THE CADILLAC SERVICEMAN

PUBLISHED BY
CADILLAC MOTOR CAR DIVISION
DETROIT, MICHIGAN

DECEMBER
1960

ERRATIC CRUISE CONTROL SELECTOR ACTION CAN BE IMPROVED

Fig. 2

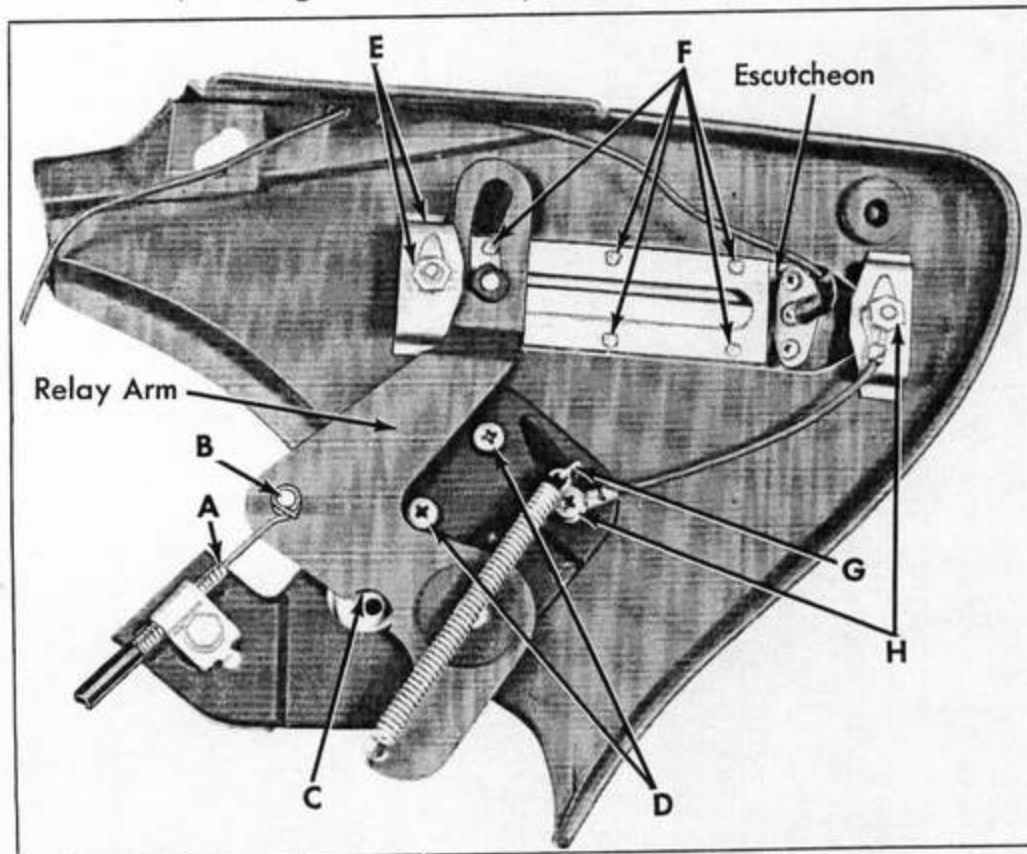
The cable housing should be positioned so that the end of the housing is flush with the end of the relay bracket, see "A" Fig. 2,—not one coil past the clamp as stated in the 1961 Shop Manual. This will allow the ferrule to be positioned properly in the dust shield.

The cable wire must be installed on the pin so the wire is next to the relay arm and the coils of the cable extend toward the open end of the pin, "B" Fig. 2. If the cable is not positioned this way, it will kink where it enters the housing.

Early selector relays did not have the portion of the arm cut out as shown in "C" Fig. 2; consequently, the relay arm travel was restricted by the lower instrument panel extension screw. Any selector encountered with this portion *not* cut out should be replaced.

Some early selectors had washers under these two Phillips head screws, "D" Fig. 2. This could raise the height of the screws sufficiently so the head would contact the relay arm and restrict its travel. If washers are found under these screws, they should be removed.

This bracket should be positioned so that ends of bracket are exactly parallel with the escutcheon—not angled, "E" Fig. 2. The retaining nut should not be tightened to the point where the center of the bracket is bowed and distorted. Either condition could restrict the relay arm travel on the low speed side.

escutcheons had a tendency to pull away, and allow the escutcheon to separate, causing the lever to bind. This condition has been corrected on all cars after Engine No. 004270 by placing a drop of special adhesive over the staked end of each of the rivets. On those early escutcheons where the rivets have pulled loose, the escutcheon should be replaced.

The spring retaining tab, "G" Fig. 2, has been shortened to prevent contact with body sheet metal when the instrument panel extension is installed. If contact is noted on early relays, file approximately 1/16" off tab to eliminate interference.

In addition, one instance was reported where an electrical shock was received by the driver when the lock-in button was touched. This was probably due to a poor ground at either of the points, shown in "H" Fig. 2. To correct this problem, be certain that there is an external tooth type lock washer under each ground wire terminal, and that the teeth of the washer penetrate the painted metal of the assembly and the escutcheon bracket. This will assure adequate grounding.

Fig. 3

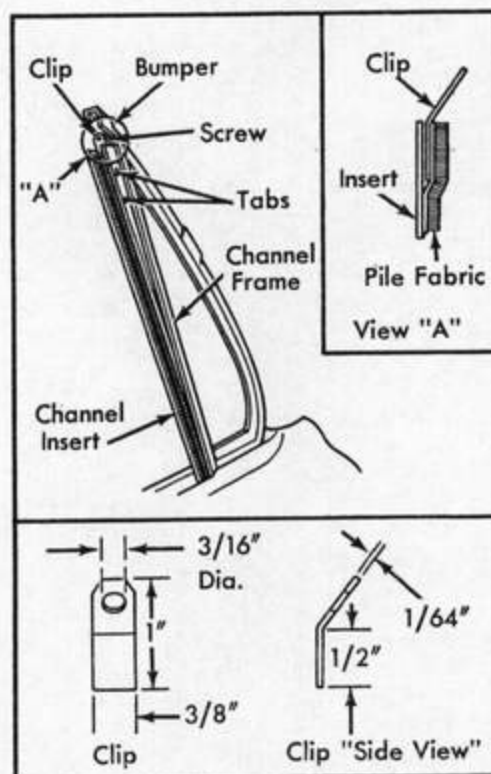
ON some early production 1961 Cadillac cars, the front door window glass may crack in a diagonal pattern (from upper front to lower rear corners) when the door is slammed with the window in the partially open position.

This damage occurs due to the upper forward edge of glass contacting the ventilator division channel retaining tabs. If this condition is encountered, the following corrective steps should be taken:

1. Open the two tabs which secure the ventilator division channel insert to the ventilator division channel. These tabs are located below the division channel upper rubber bumper as shown in Fig. 3.

2. Pull division channel insert rearward to disengage insert from retaining tabs and securely clinch (flatten) retaining tabs against the ventilator division channel frame.

3. Install a small piece of waterproof sealing tape inside of division channel frame over each of the flattened retaining tabs.

4. As the two reworked retaining tabs no longer secure the division channel insert, make and install a non-corrosive metal clip between the pile fabric and metal backing of the division channel insert. See Fig. 3.

5. Remove the ventilator division channel upper rubber bumper.

6. Replace the division channel insert in the division channel and secure the new clip beneath the upper rubber bumper with the existing retaining screw.

Fig. 4

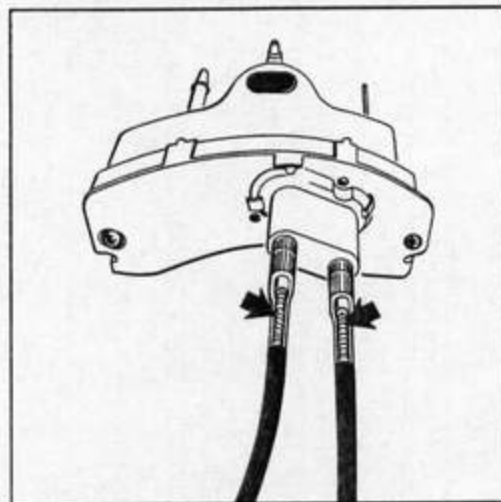
PIR MANY servicemen are not aware of the two springs extending into the vacuum hoses from the parking brake release switch

mounted on the neutral safety switch, see Fig. 4.

These springs prevent the vacuum hoses from bending or pinching near the switch area, where they are routed at a sharp angle, eliminating any possibility of the parking brake unit failing to release automatically because of an obstructed vacuum supply hose.

Many times when a hose is removed, the spring also comes off and remains inside the hose unnoticed. Then it is positioned incorrectly when the hose is reinstalled. In this case, the spring should have been removed from the hose with a piece of hooked wire, and several coils of the spring rotated into the tube on the switch. The hose should then be slipped over the spring and on to the switch tube.

Fig. 5

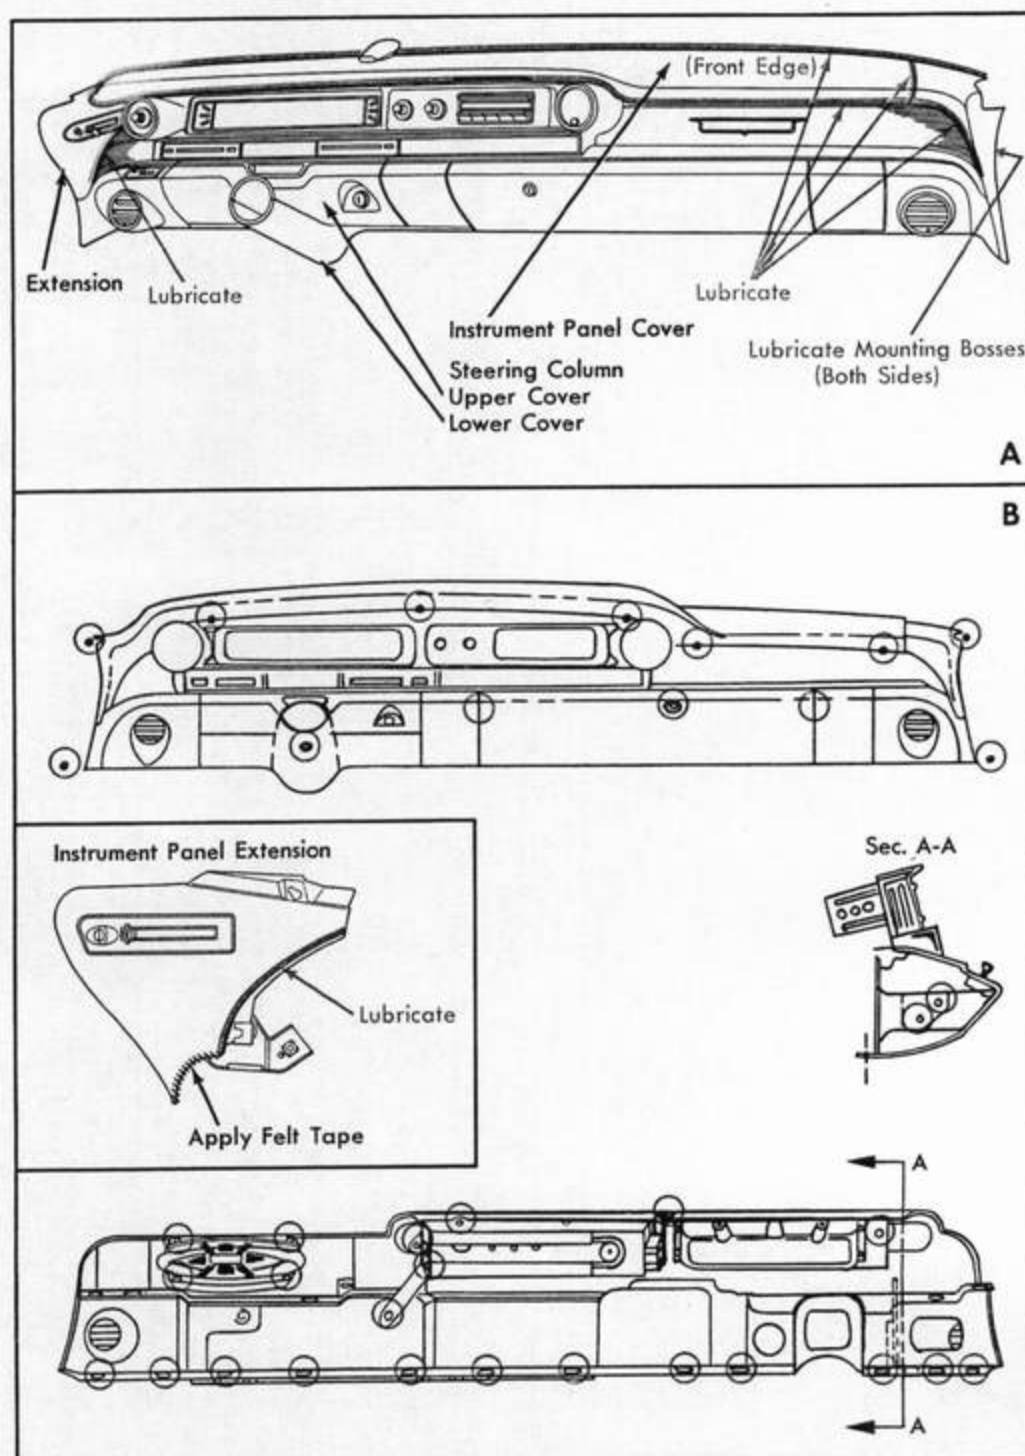
The friction squeak conditions are usually caused by the frictional movements of vinyl, metal, or rubber parts against each other. In cases where vinyl and rubber parts are involved, the entire contact area should be lubricated with a light coat of 4X silicone, or Lubriplate. Use Lubriplate in all cases where refinishing may be necessary, to avoid complicating the repainting

process with silicones. Referring to section "A" of Fig. 5, and the insert of the extension in section "B", the green outlined areas in these illustrations locate most of the contact points and the areas to be lubricated.

In the case of dash rattles, locate and securely install any loose or missing screws. The green circles in section "B" of Fig. 5 are screw location points that should be checked for this possibility. In addition, any bowden cables or electrical connectors found loose and noisy should be taped.

In addition, some trim moldings, such as roof rail or windshield pillar garnish moldings, may develop creaky conditions. These may be corrected by applying felt-backed tape under the ends of overlapping moldings, and tightening the attaching screws. The felt tape should also be installed on the curved lower ends of the instrument panel extensions, as shown in the inset of section "B", Fig. 5.

Fig. 6

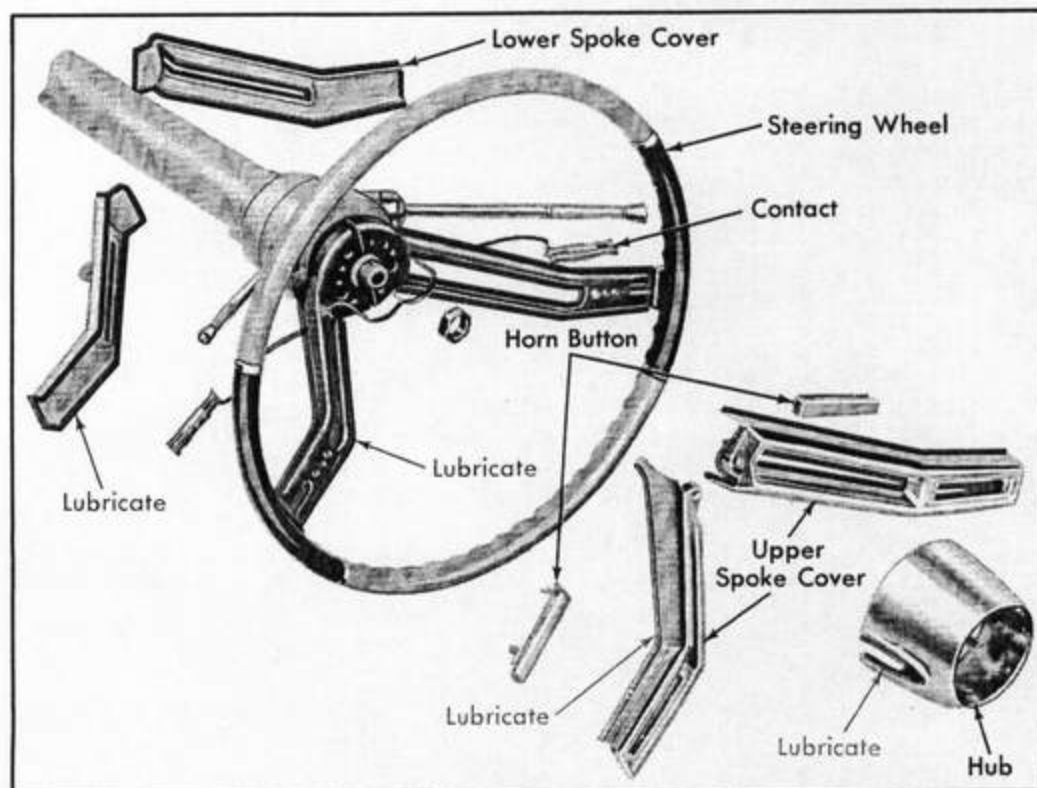
Also check the seating of the upper and lower spoke covers, and file off any attaching screw bosses as required to seat these parts. Lubricate all the plastic-to-metal and plastic-to-plastic points shown in green in Fig. 6, install the spoke covers, and tighten the screws securely.
